Howard County
Health Department

ONSITE SEWAGE DISPOSAL SYSTEM

PROPERTY ADDRESS: 13029 High Grove Road

SCHOOLEY MILL FARM
 SITE PLAN FOR BAT INSTALLATION FOR LOT 4
 13029 HIGHGROVE ROAD
 Zoned: RR-DEO
 Tax Map No. 40; Grid No. 10 & 11; Parcel No. 115 & 149
 Fifth Election District - Howard County, Maryland
 Date: March, 2014 Scale: As Shown

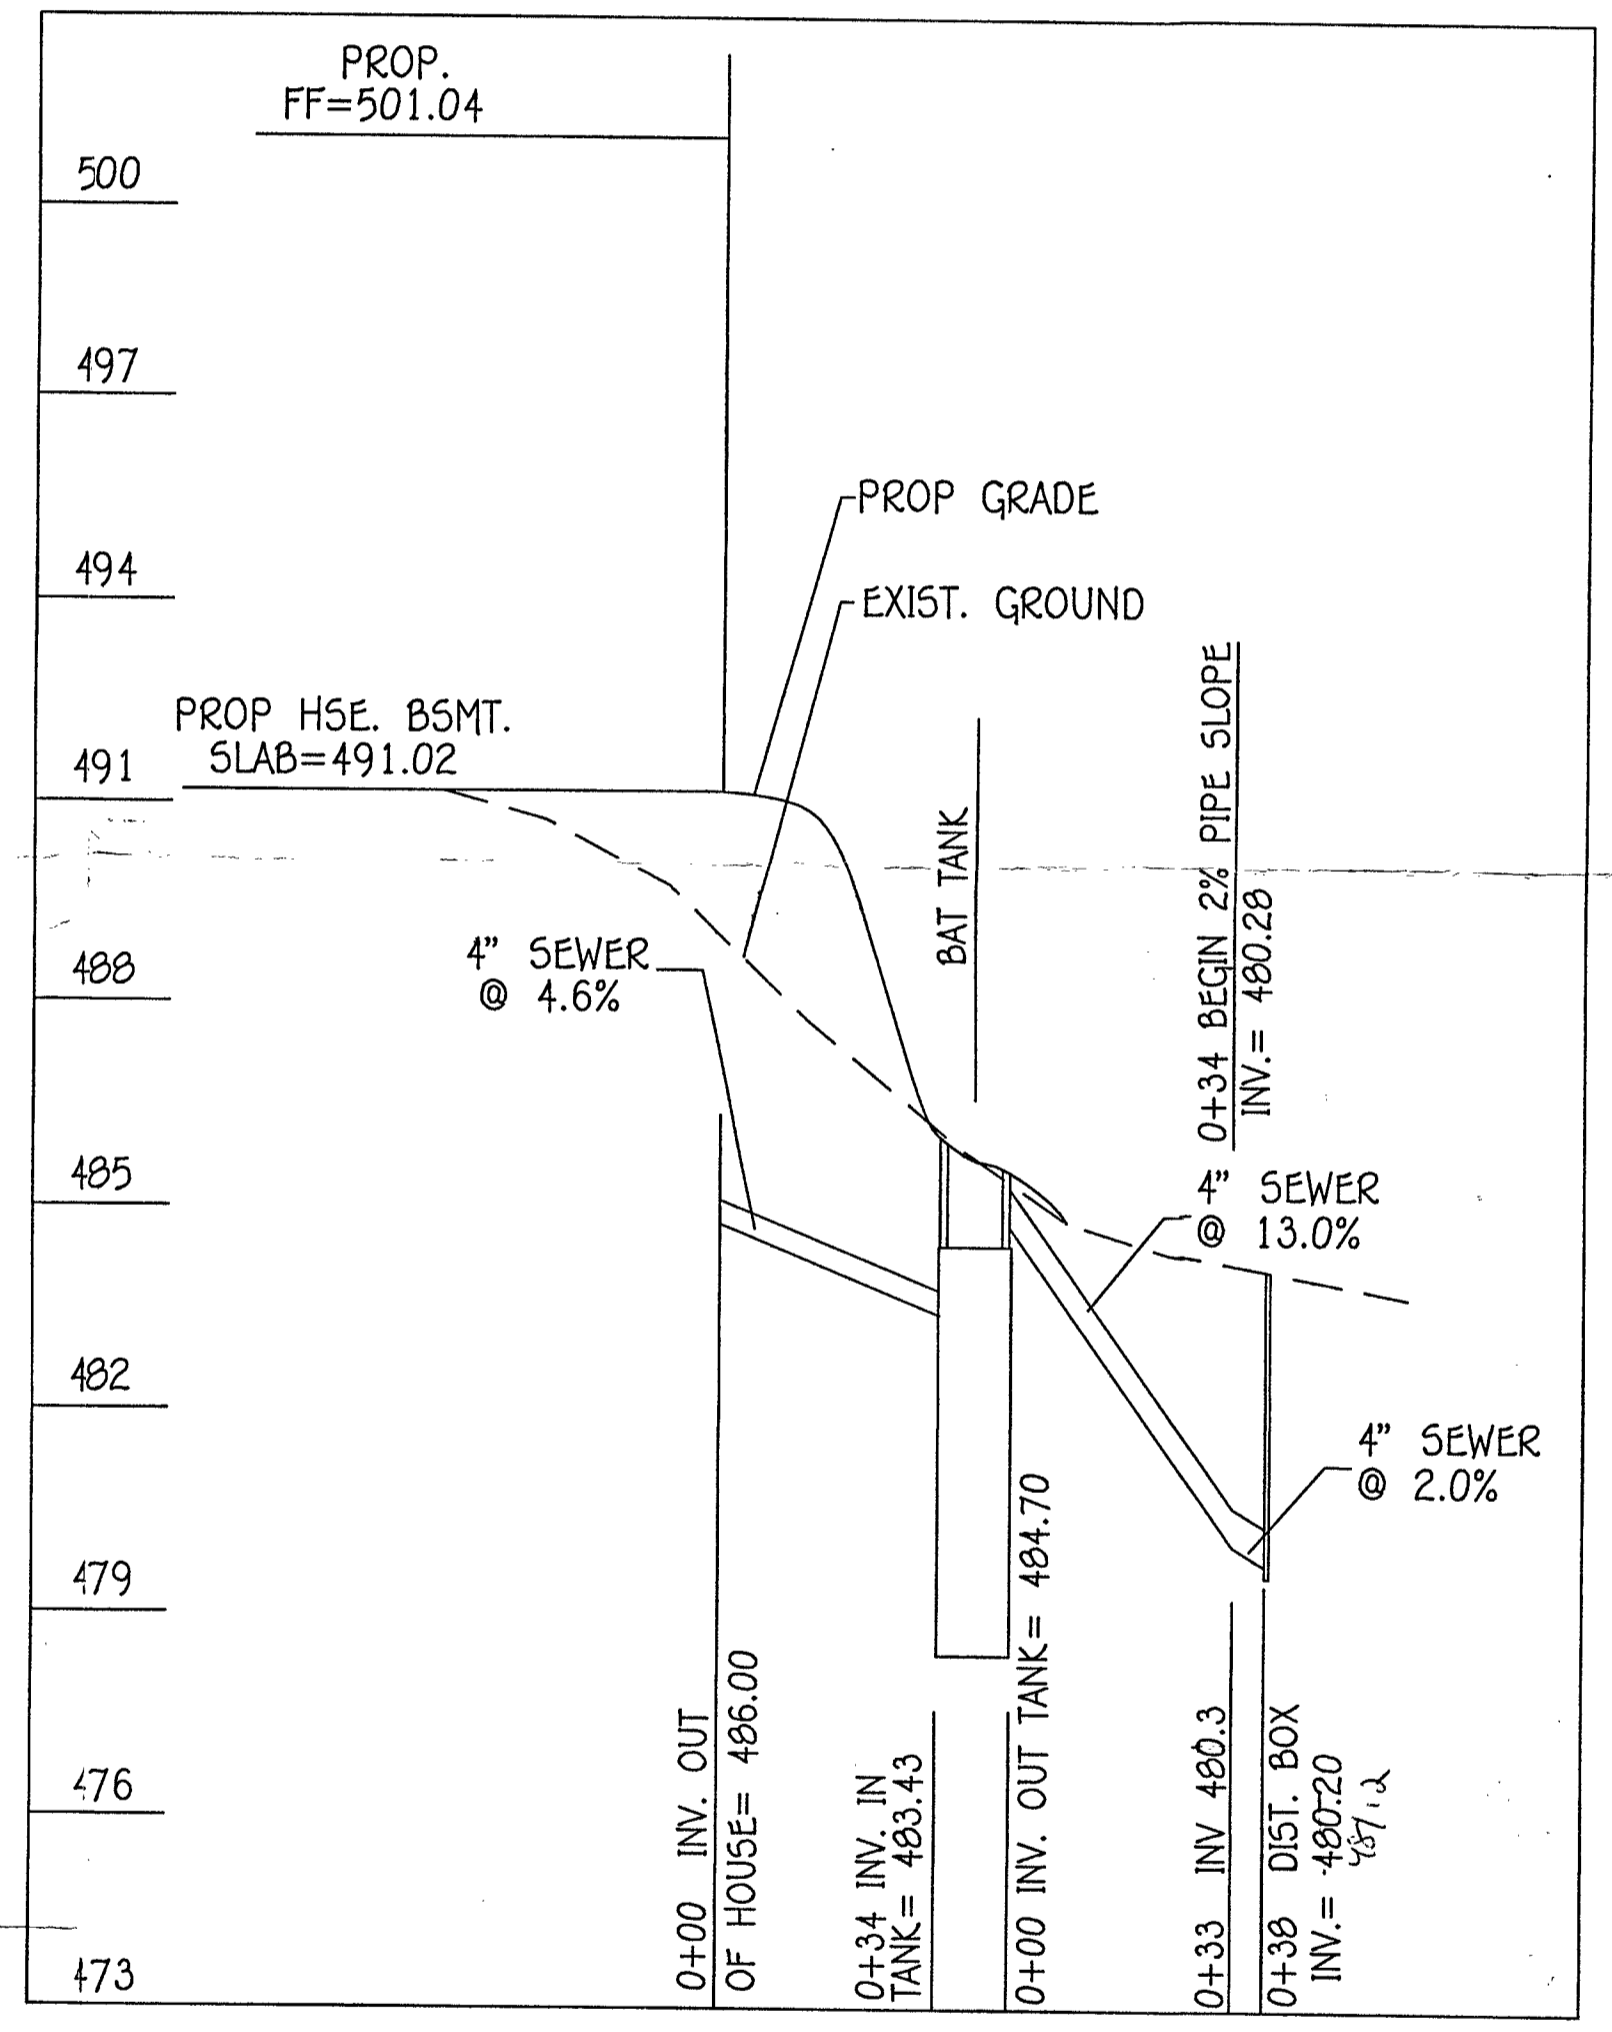
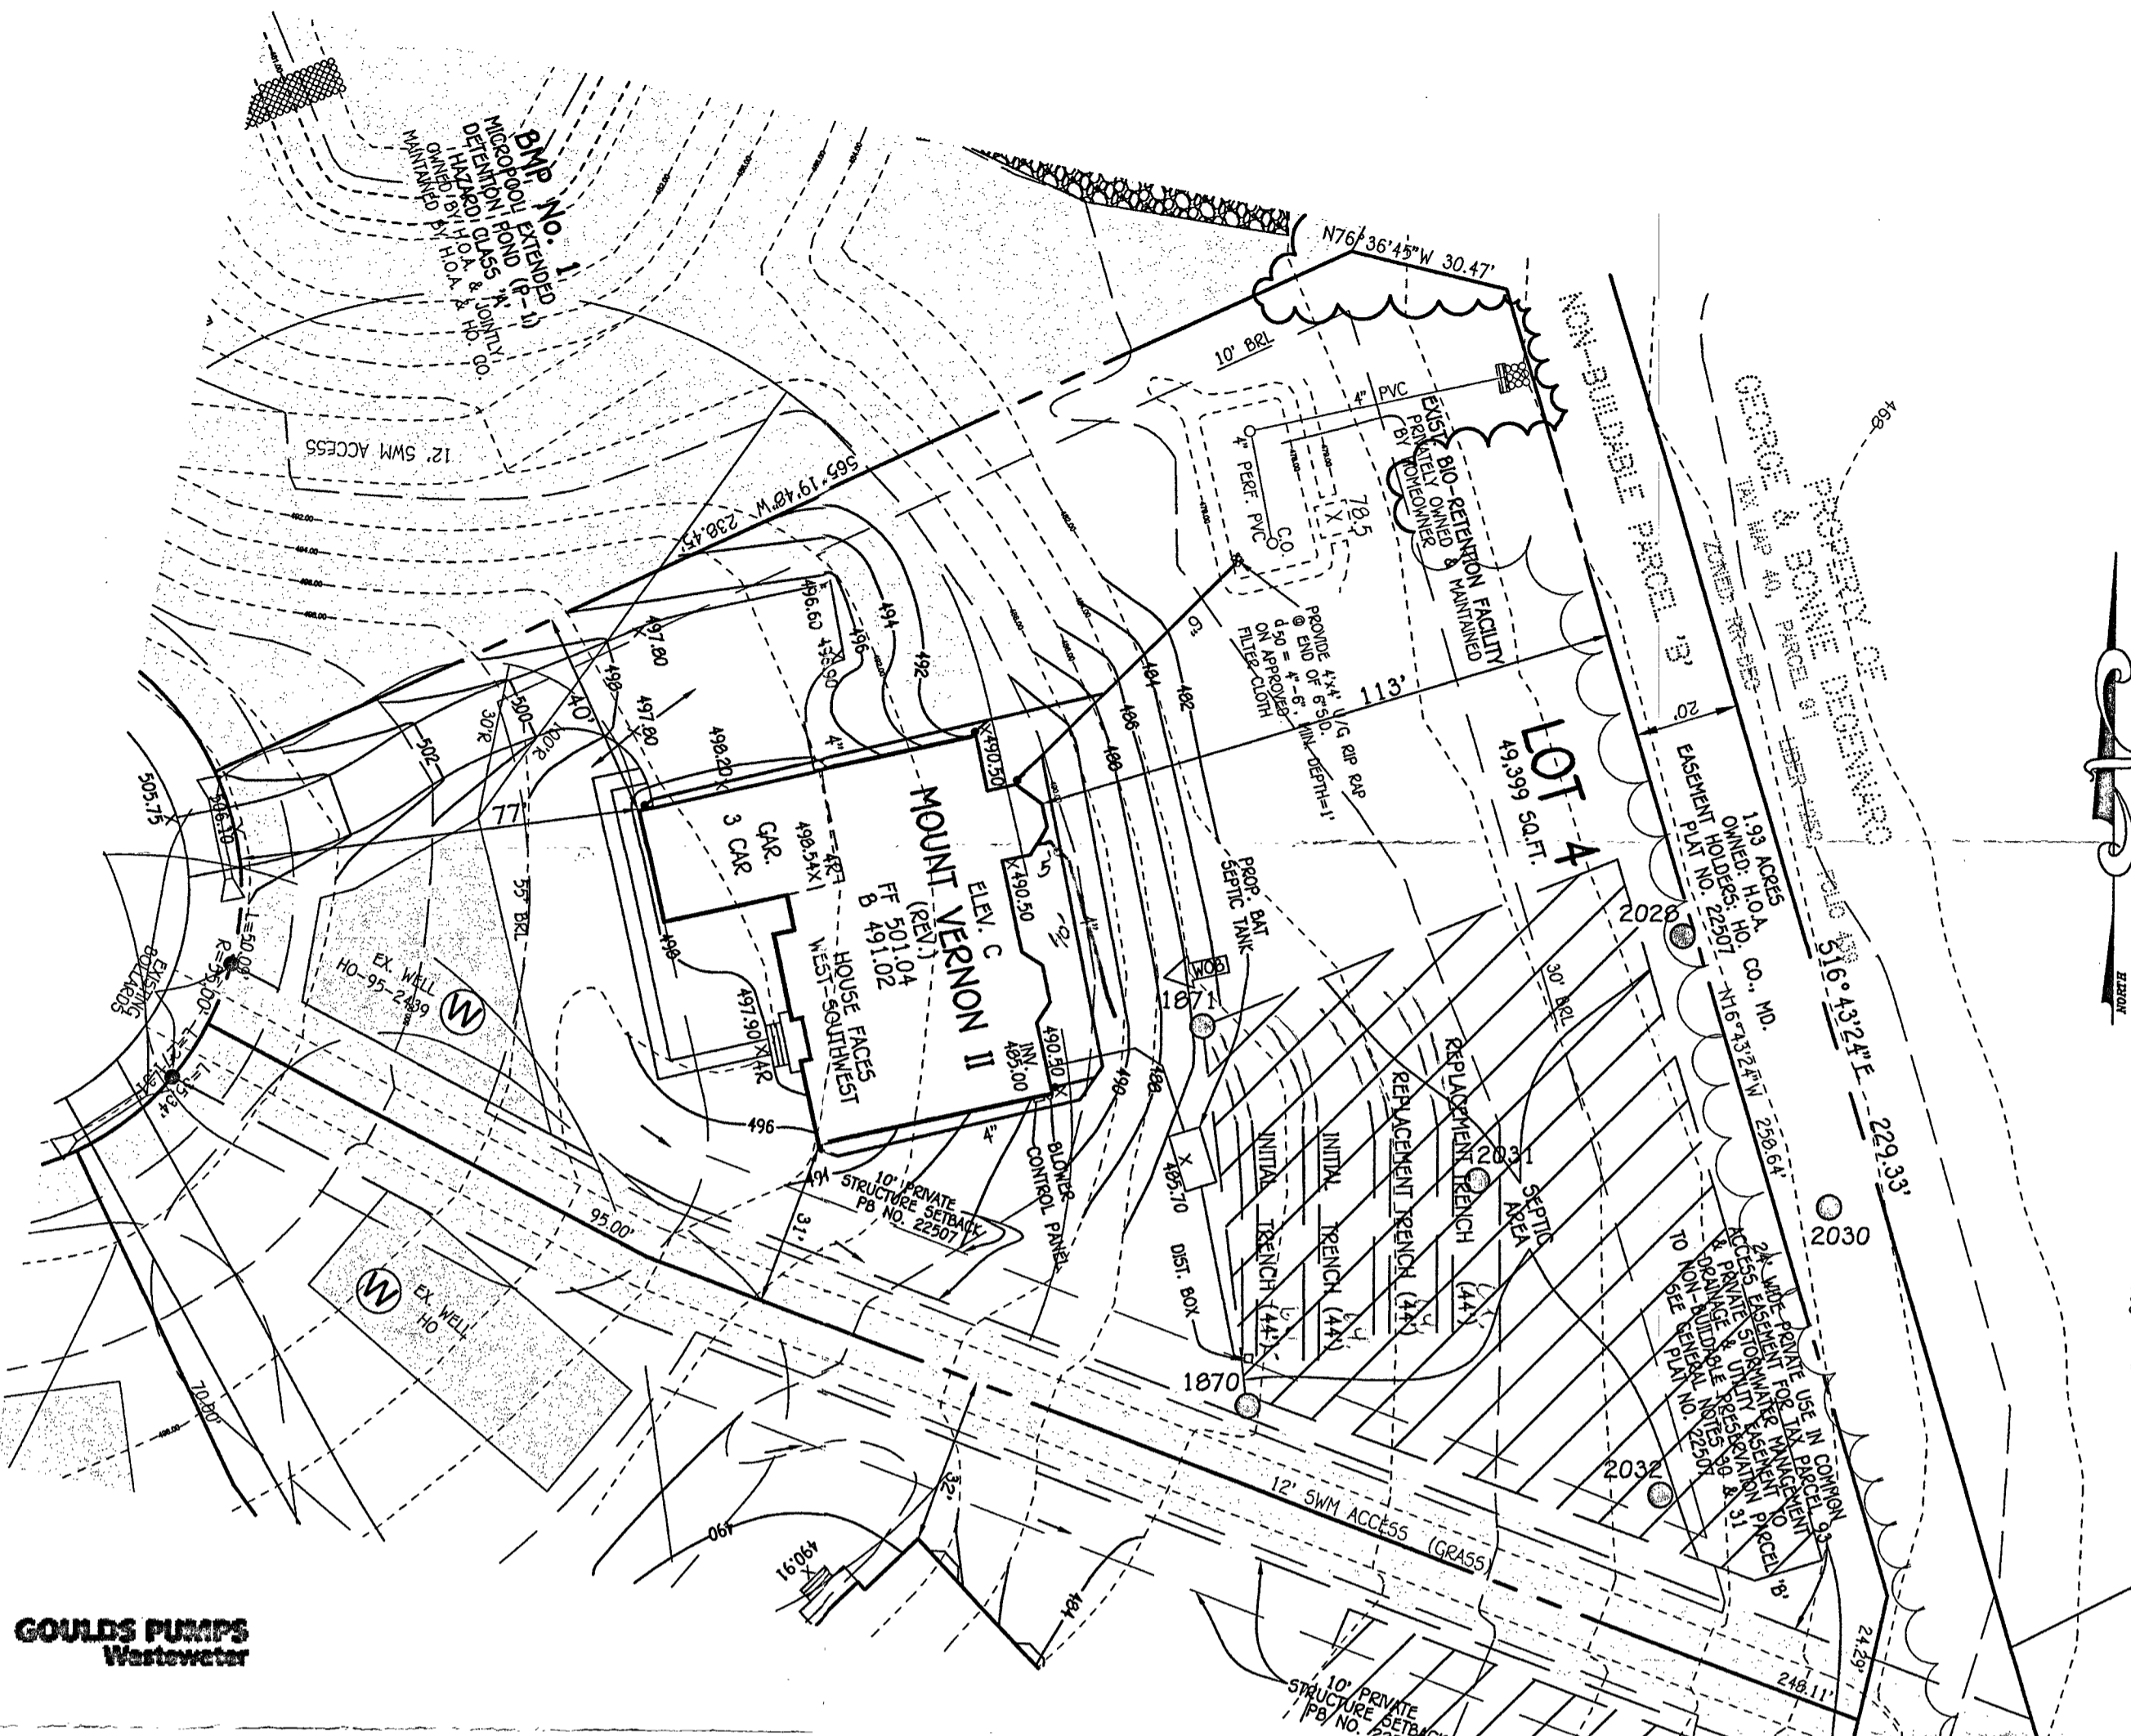
- All of the plans need to show the pump on elevation and dose volume.
- All plans need to show trench details: ground elevation, invert elevation, bottom elevation for each.
- Lot 6: hoot tank location is in the middle of a proposed swale. They could move it over right by perc hole 1663.
- Lot 7: the building permit states 5 bedrooms, you revised the plan down to 4 bedrooms
- Lot 9: the sewer grade states 7%, but is really 4.7% (FYI, anything greater than 5% should level off to 2% in the last few feet before the tank)
- Lot 9: the d-box should go at the top edge of the easement for an end feed to the trenches.
- Lot 4: the d-box should go to the corner of the easement for end fed trenches.

Otherwise, for all lots the approved trench bottom depth is 7', but on all you have trench bottom depths at 8'. Also, we need the trench invert elevations for all. We also need the trenches within each system to be exactly equal length. I don't think that will be a problem on any of these. What is helpful to us is to include a chart or note indicating the trench depths and specs. I've attached a copy of an example that we like.

Also, I've learned that the Hoot system pump probes are at set locations, but the length of time the pump is on can be programmed, which is what gives the dose. I had asked for an elevation of the pump on float and a dose volume. We didn't get the pump elevation on these revised, but what we could get is a note under the dose stating the run time correlating to the rate of the pump selected that matches the dose given. A rule of thumb for a dose going to a d-box could be about 1/6 design flow or around 100g. For example, lot 7 has a pump with a rate of 53gpm. You could specify a dose of 106g and a runtime of 2 minutes.
